Addendum No. 4
City of Coquitlam
Tender No. 81832 - Phase 2
Cedar Drive Upgrades - Sanitary Pump Station to Gilleys Trail
 (Consists of 14 Pages)
 Issue Date: May 9, 2025

Contract 81832 - Phase 2
CEDAR DRIVE UPGRADES - SANITARY PUMP STATION TO GILLEYS TRAIL

STA 0+600 TO 0+830
CEDAR DRIVE UPGRADES - PHASE 2

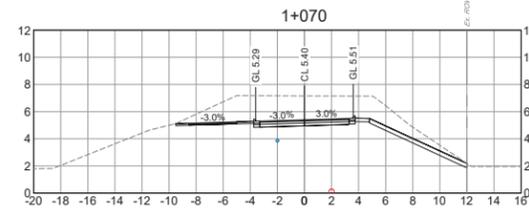
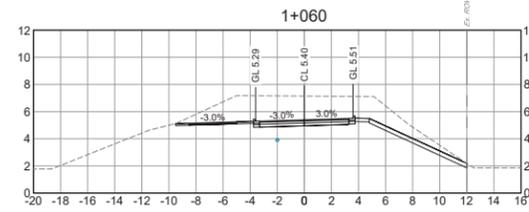
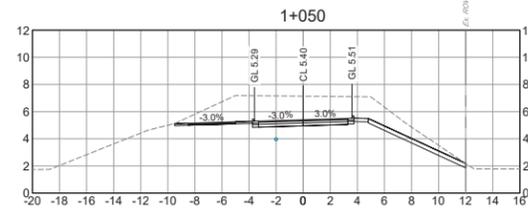
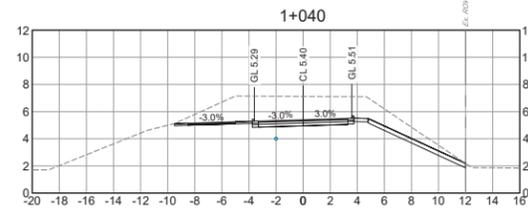
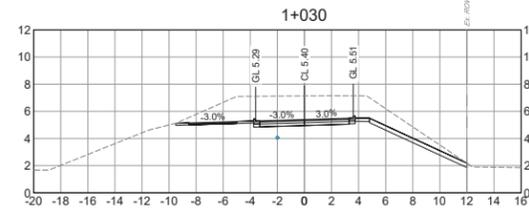
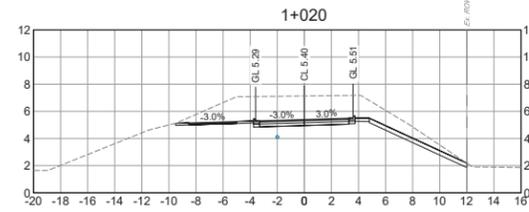
- Q1.) Please provide drawing x-section for Cedar Drive road alignment, in 20m increments.
- A1.) Please see attached new drawings showing the cross sections.**

**STA 1+320 TO 1+540
CEDAR DRIVE UPGRADES - PHASE 2**

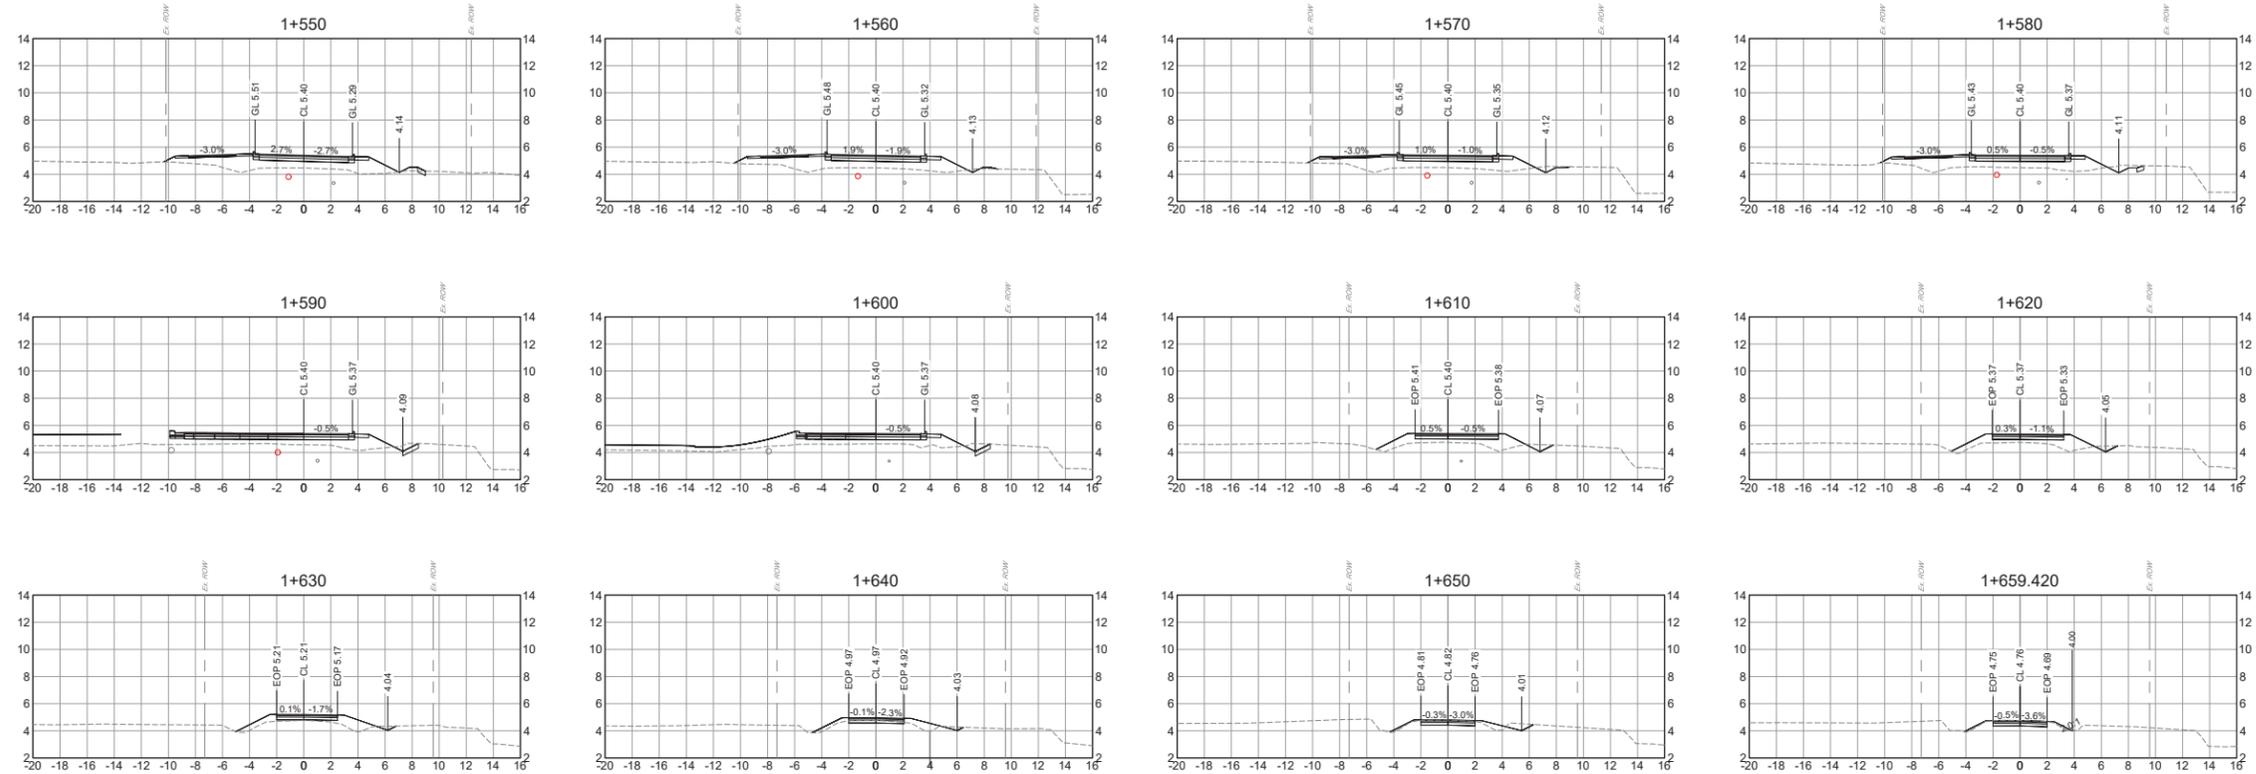
- Q2.) Provide station limits for extent of Pumice LWF to be used. Typical section not location, but we need to know how long on either side fronting the properties.

- A2.) The Pumice section is on Oliver Road only, where the existing preload ends, roughly at STA 1+510.**
- Q3.) Are we just stripping to noted subgrade elevations at the pumice locations? What thickness was assumed?
